Access Compliance Report Public Rights-of-Way (Curb Ramps)

Main Street: **KELLOGG_DR** Cross Street: **MOUNTAIN_VIEW_AVE** Location: **E**

ADA ID: **RPAT210922123233** Ramp Type: **Type 4 - Parallel** Initial Pass/Fail: **Pass** Overall Compliance: **No** Severity Score: **0**

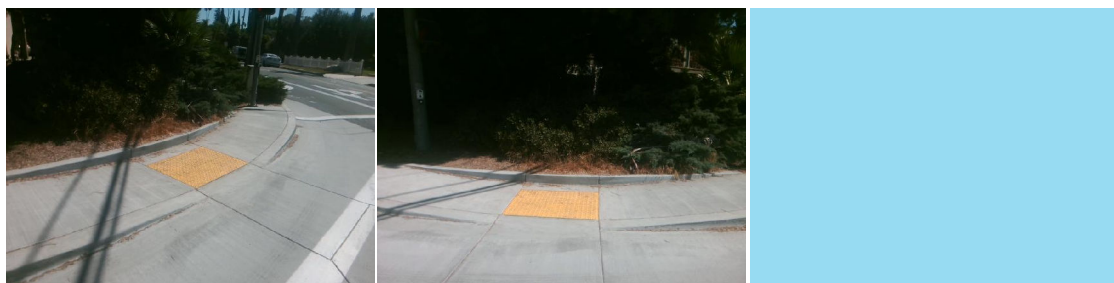
Yes	Ramp Inside Crosswalk 1	Yes	Yes	Ramp Inside Crosswalk 2	Yes
	Crossing 1 Slope (%)	2		Crossing 2 Slope (%)	4.8
	Crossing 1 Cross Slope (%)	2.2		Crossing 2 Cross Slope (%)	2.2
Yes	Gutter Ponding	No	No	Curb Slope	9.4
Yes	Gutter Lip Height (in)	0		Road Run Slope (%)	0.5
Yes	Gutter Run Slope (%)	3.7		Road Cross Slope (%)	4.2
Yes	Gutter Cross Slope (%)	0.1	Yes	Perpendicular Joint Present	Yes
Yes	Overall Surface Condition	Acceptable			
	Cross Gutter Present?	Yes		Spandrel Present?	Yes
	Replace Cross Gutter?	No		Replace Spandrel?	No

Possible Solutions:
Remove & Replace Curb Slope.

OC Std/PROW:
R304.2.2, STD 1115
